# Access Compliance Report

## Public Rights-of-Way

### (Pedestrian Signals)

Intersection ID: N/A	Main Street:	Cross Street: N/A	Location: N/A
ADA ID: 27923259DE17	Signal Type: One Push Button-Non APS	Overall Compliance: No	Severity Score: BTN 1: N/A BTN 2: N/A No BTN: N/A
Codes/Mitigation Info/Possible Solution		Field Measurements/Component Compliance

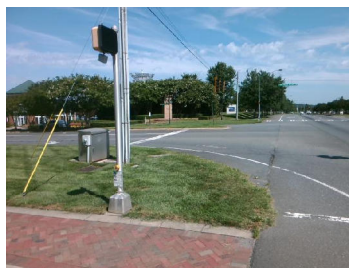
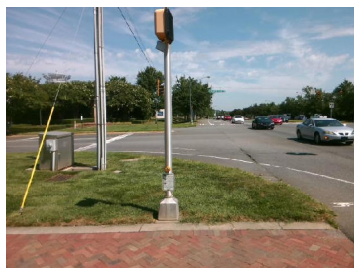
PROW/ADA: TMUTCD 4e.08, R404.2, R404.3, R406.2

Possible Solutions: Replace Signal Push Button With APS Button on New Post. Remove & Relocate Sign.
